Application under the *Agricultural Operation Practices Act* for a confined feeding operation, manure collection area, and/or manure storage facility(ies)

NRCB USE ONLY <input checked="" type="checkbox"/> Approval <input type="checkbox"/> Registration <input type="checkbox"/> Authorization <input type="checkbox"/> Amendment	Application number <u>LA21057</u>	Legal land description <u>W½ 20-16-12 W4M</u>
-----------------------------------------------------------------------------------------------------------------------------------------------------------------------------------------	--------------------------------------	--------------------------------------------------

**Re: Geotechnical Review and Evaluation
 NRCB Permitting of Feedlot Pen Expansion
 NW-20-016-12-W4M, near Brooks, Alberta**

Figure 2: Tateson Ranch – Feedlot Expansion Area Map

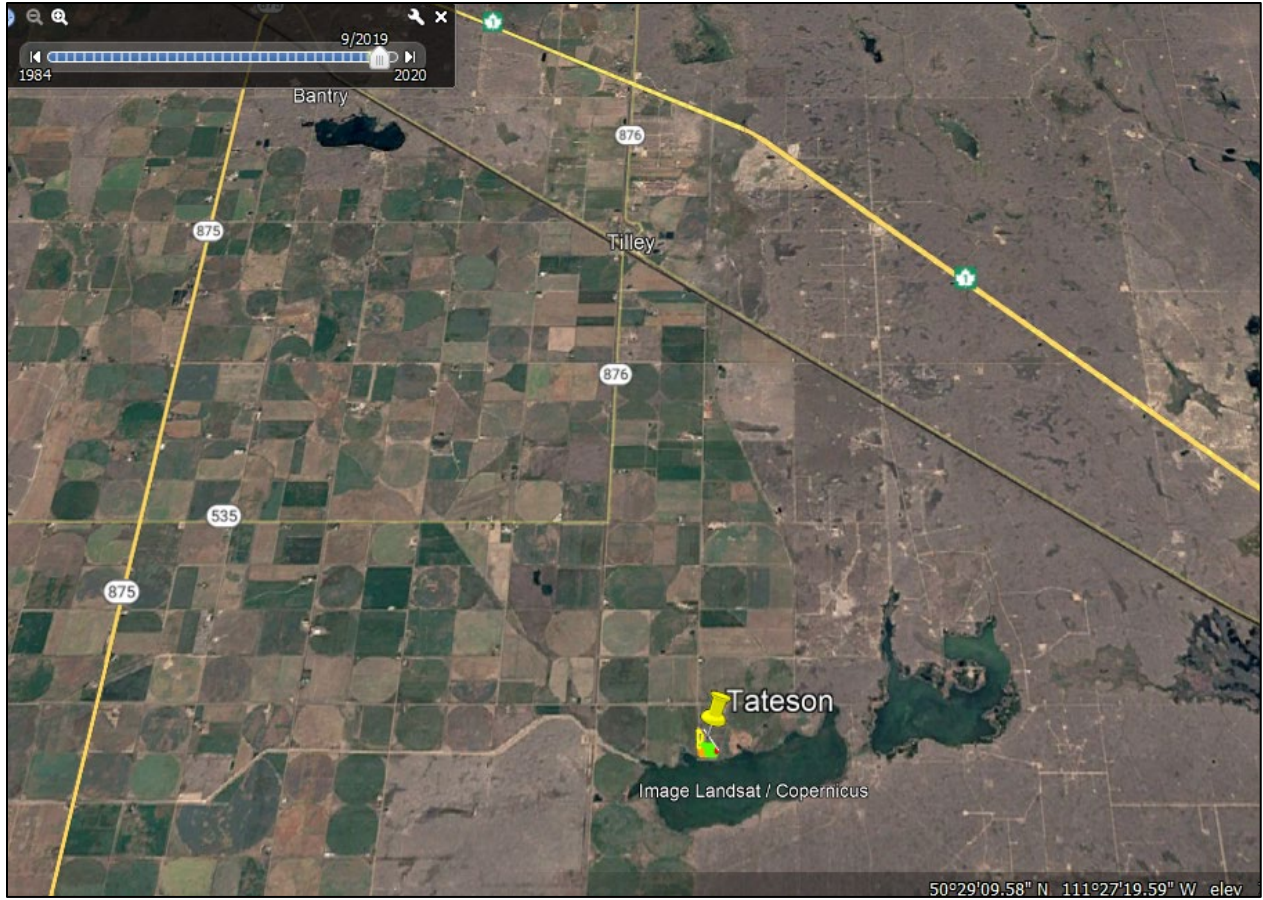
Existing: Livestock Pens (Converted to Feedlot Pens in orange)

Proposed 1: Feedlot Pen Expansion (green)

Proposed 2: Catch Basin 1

The risk to surface water of the already constructed pens is determined to be low. However, it is within the upper range of this category. This is related to the closeness to Scots Lake. The assumption is that 'most runoff' is controlled (> 80-99 percent) and that the runoff is channeled. A condition will be attached requiring the construction of a berm along the south and west side of the feedlot pens to ensure no runoff can reach Scots Lake and proof of positive drainage towards the catch basin from all feedlot pens to ensure all runoff from the feedlot pens will flow towards and contained in the catch basin.

Catch Basin Volume Calculator

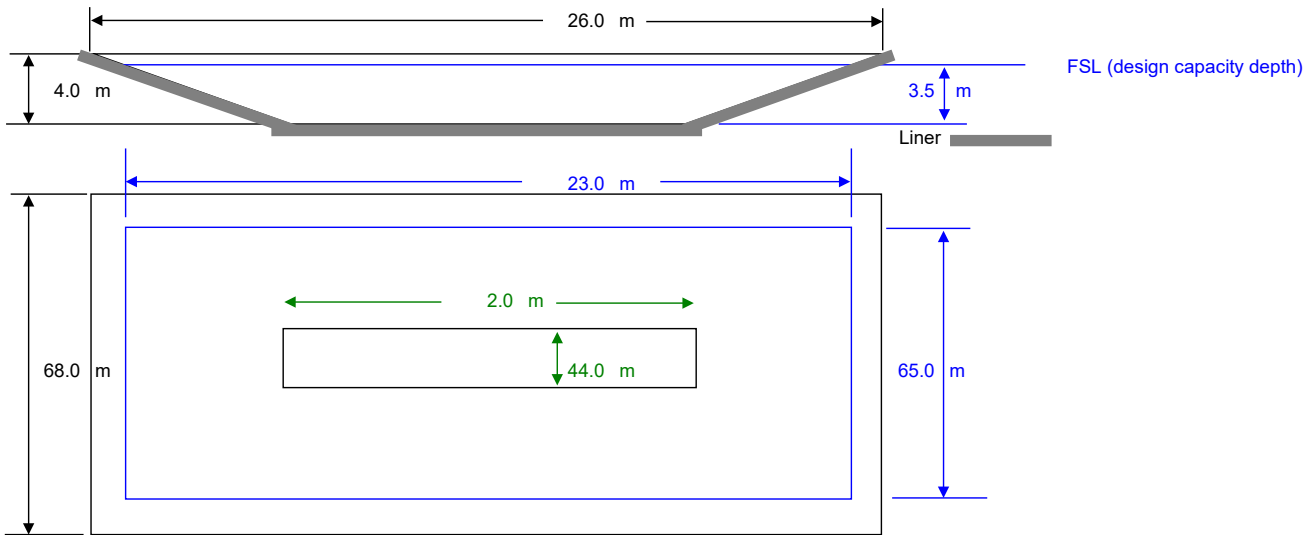
Added by AO

Catch basin calculator. Total volume @ freeboard level: 2,513 m³ Runoff capacity requirements met: YES NO
